DRAFT Preliminary Review: Navy Groundwater Flow Model for the Navy Red Hill Facility

The Department of Health Hawaii (DOH)

May 10, 2021

Comparative Chemistry

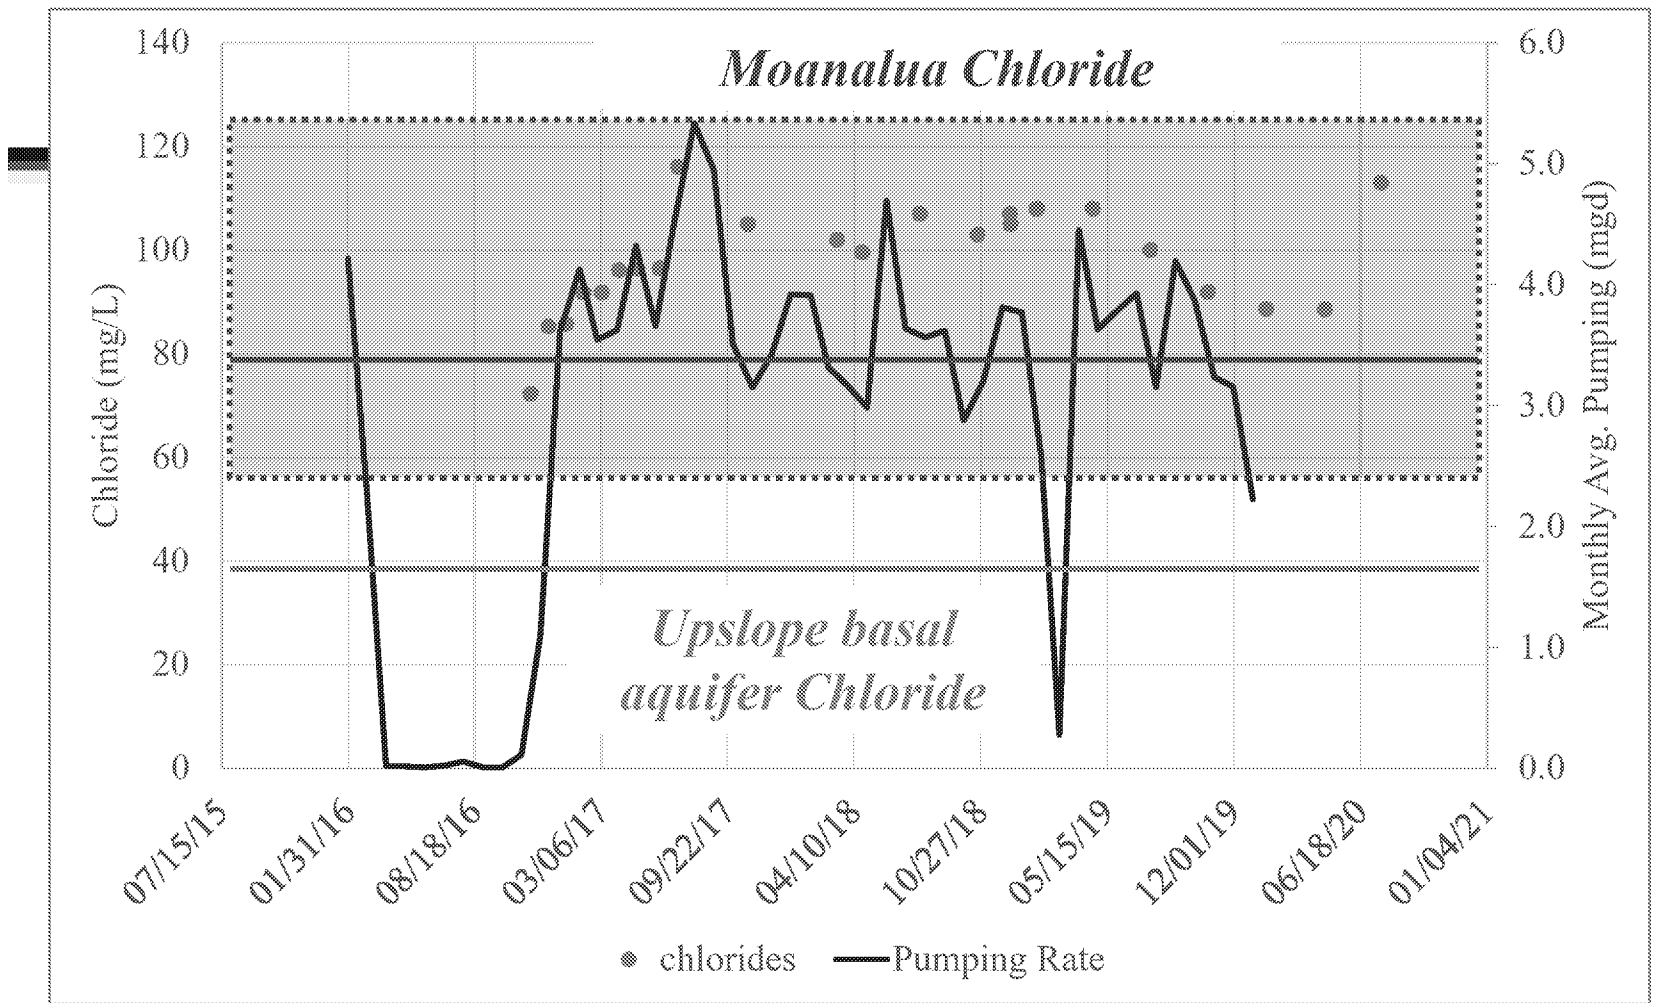
Groundwater in the dike zone recharge area would have $[\text{Cl}] < 30 \text{ mg/L}$ and $\delta^{15}\text{N}$ from 2 – 3 ‰

Chlorides were lowest at the end of the 2016 extended shutdown. Chlorides increased when pumping resumed. The Red Hill Shaft chloride concentration very close to that of Moanalua groundwater

Westbay Well Chlorides

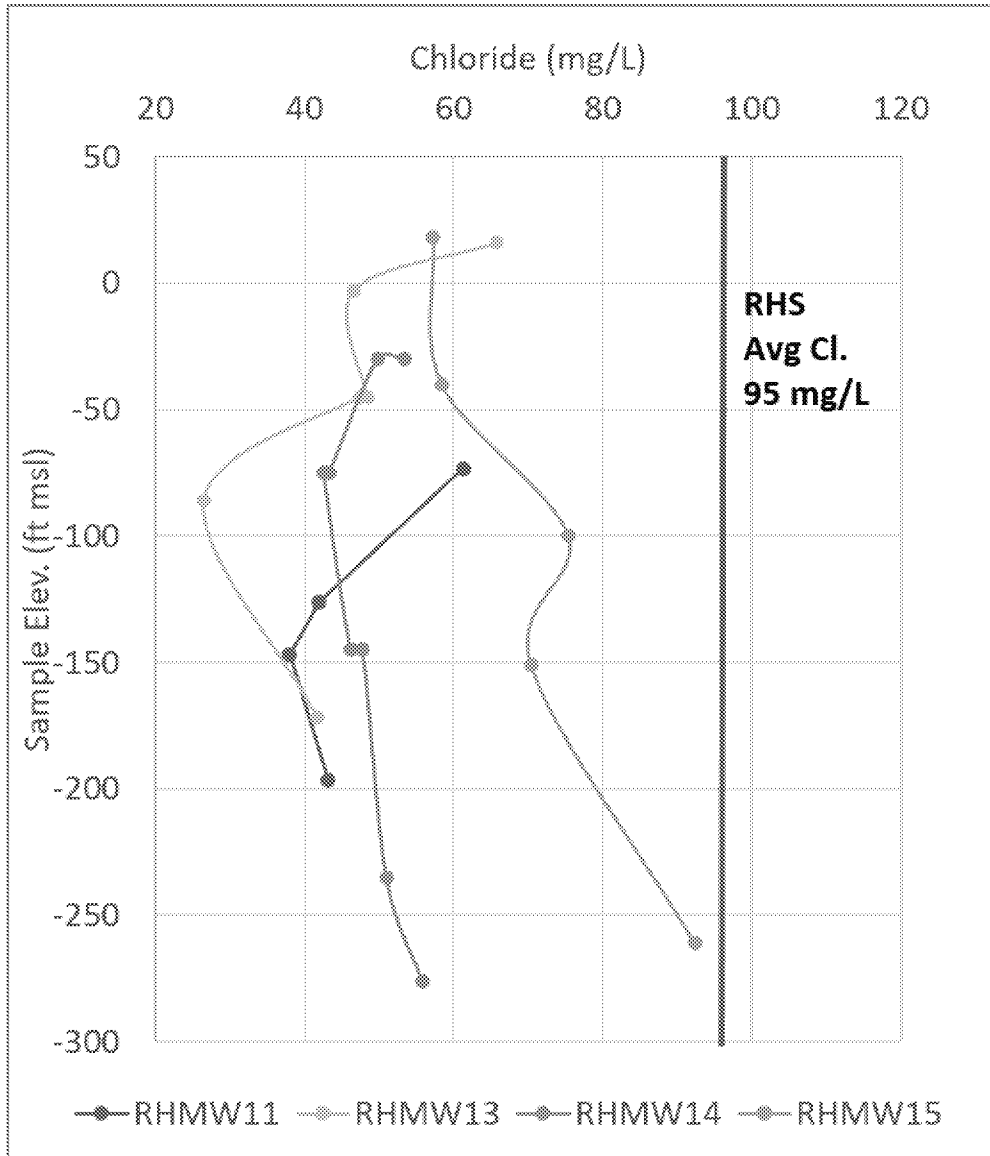
- Upslope of the Red Hill Facility all $Cl < RHS\ Cl_{avg}$ of 95 mg/L
- Low Cl in RHMW11, 13, & 14 argue against up flow from HDMW2253 as the source of Cl
- In RHMW15 (near the east end of the RHS infiltration gallery) the chlorides start to approach RHS values only at the deepest sampling port (-260 ft msl)
 - However, water levels indicate a downward gradient

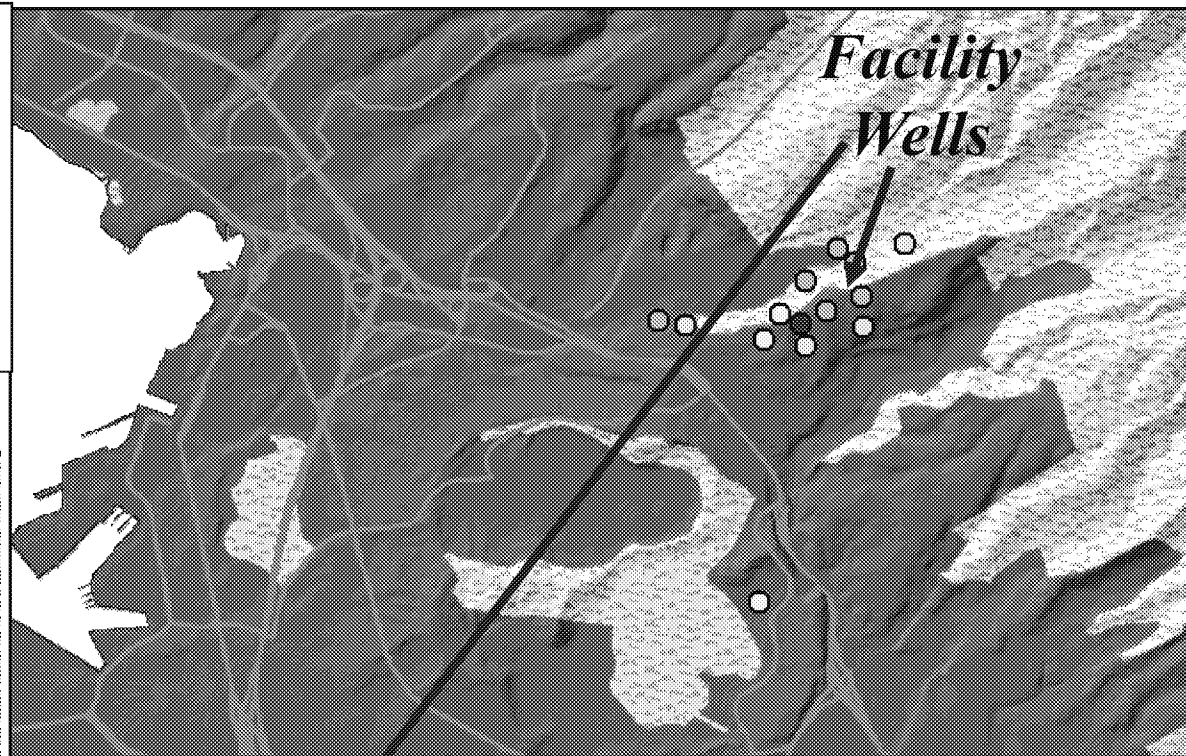
Groundwater nitrate aligns much better with cross-aquifer flow than with mauka to makai flow.

- ***Nitrate vs. $\delta^{15}\text{N}$ for groundwater samples collected on Oahu.***
 - ***The upslope groundwater has low $[\text{NO}_3]$ and low $\delta^{15}\text{N}$.***
 - ***Downslope groundwater has elevated $[\text{NO}_3]$ and elevated $\delta^{15}\text{N}$.***
 - ***Change in N chemistry due to anthropogenic impact.***
- ***Elevated $[\text{NO}_3]$ and $\delta^{15}\text{N}$ in many Red Hill wells strongly suggest anthropogenic impact along the flow path***
 - ***Not consistent with modeled groundwater flow trajectories***

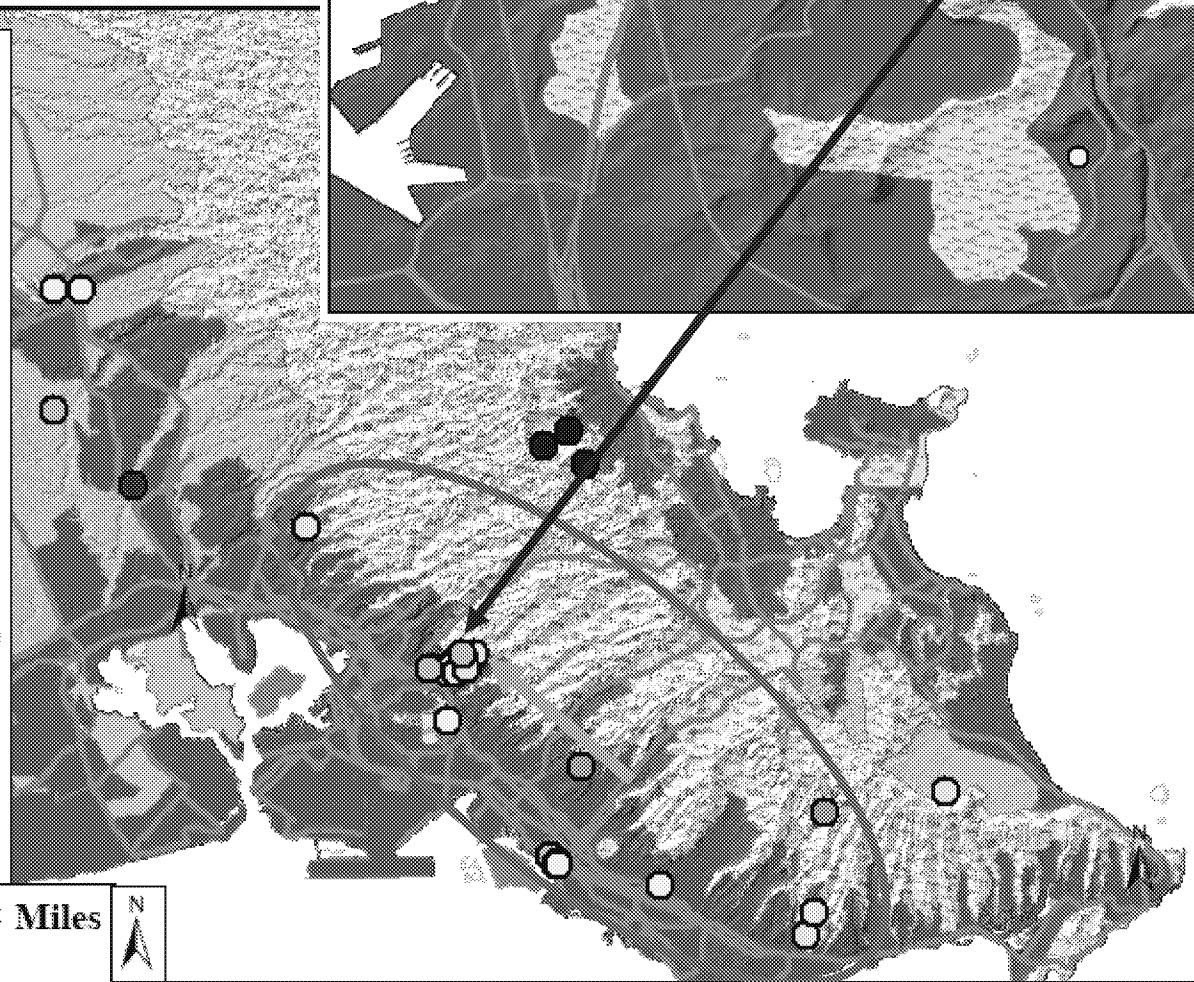
The nitrate concentrations and isotope chemistry strongly suggest cross ridge groundwater flow to the Red Hill Ridge.
